# Product Safety Recall

## N202325160 Battery Cable Short Circuit

<b>Condition</b>	General Motors has decided that a defect which relates to motor vehicle safety exists in certain 2021 model year Chevrolet Express and GMC Savana vehicles with 6.6L gas engines. In certain circumstances, anti-rotation tabs on the positive battery cable terminals may come into contact with a fuse block assembly attachment post, causing a short circuit. Clearance between the positive battery cable anti-rotation tab and the fuse attachment posts is small enough to allow contact in certain situations. Drivers may get a low battery voltage warning or experience a dead battery. A short-circuit of a positive battery cable to a fuse attachment post can cause battery drain or may lead to an underhood fire.
<b>Correction</b>	Dealers will remove a portion of the anti-rotation tab on both positive battery cable terminals near the engine compartment fuse block assembly attachments.

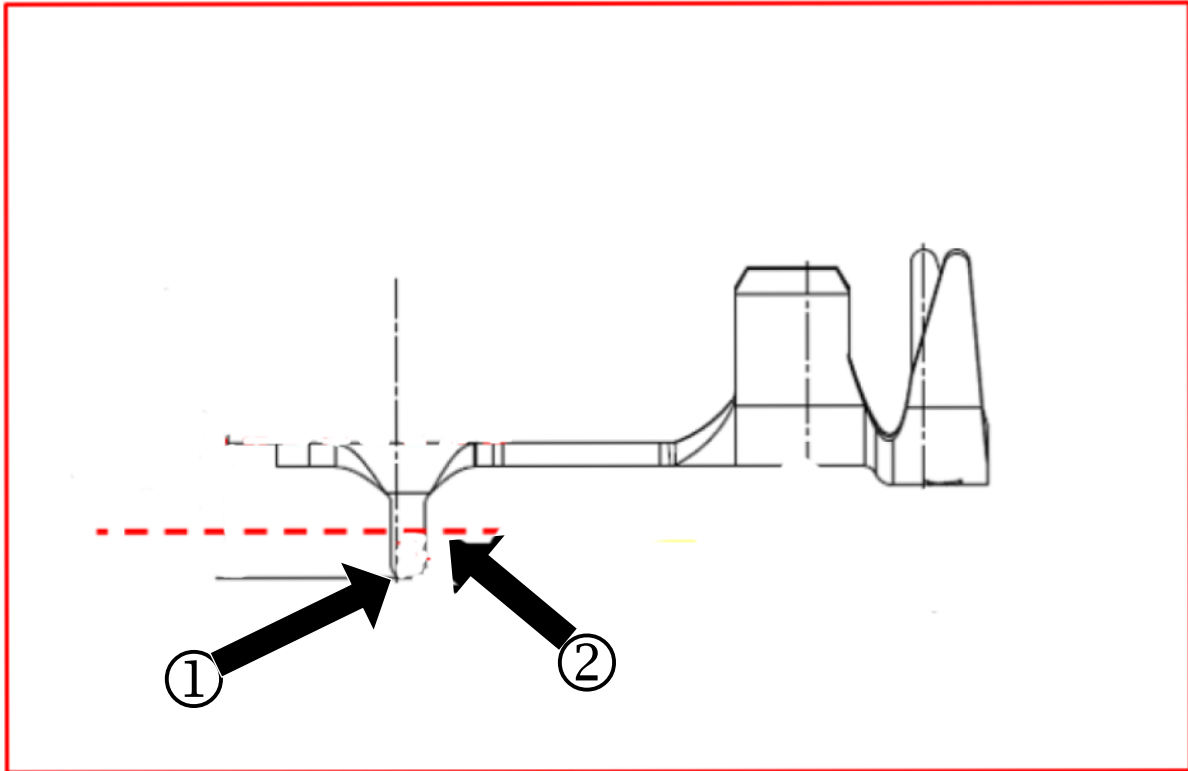
5. With the cables disconnected, locate the anti-rotation tabs.

**Important: The following measurement is critical to a correct repair. THE CUT MUST BE MADE IN THE EXACT LOCATION SHOWN IN THE GRAPHIC. DO NOT** cut the anti-rotation tab flush. Cutting the tab flush may cause the cables to rotate and contact the fasteners or the Mega fuse mounting studs.

5779100

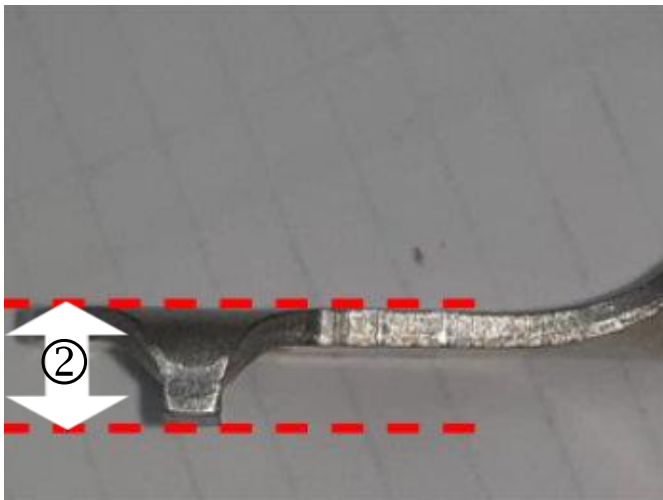
6. Starting from the bottom of the tab (1), measure up 4.5mm (2) from the end of the tab and scribe a line.

7. Using cutters, cut on the scribed line. Use care to only remove the correct amount of the tab. DO NOT remove the complete tab.

5779103

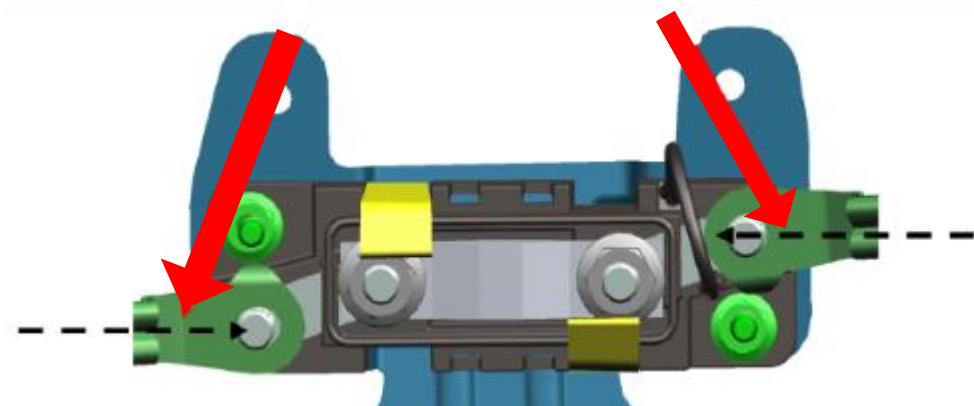
8. The completed trimmed terminal should have a total height of 6mm (2).
9. After the tab is cut, ensure the tab is 90 degrees to the lug. Adjust as required by slightly bending the tab.
10. Repeat the above steps on the second cable.
11. Loosely reinstall the two cables.

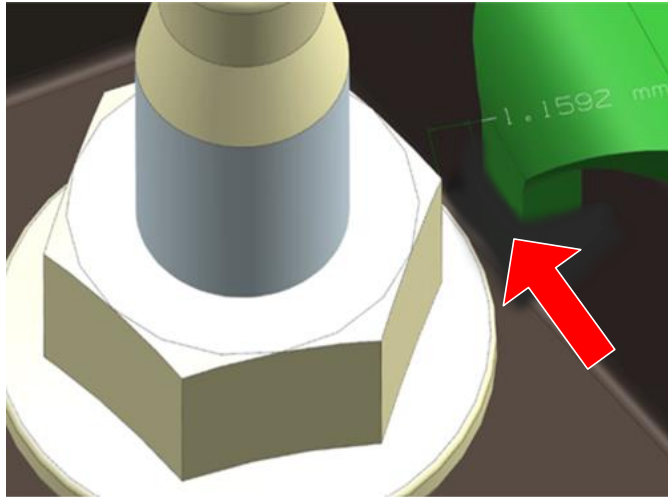
**Note:** When tightening the fasteners, hold the cables in a manner so they do not contact the studs as shown in the graphic above.

12. Tighten the fasteners to 20 Nm (15 lb ft).

**IMPORTANT:** With both fasteners tightened to specification, **make sure there is at least 1mm clearance** between the anti-rotation tab and the nut at both locations. If the clearance is less than 1mm, remove the cable and further trim the tab as required.
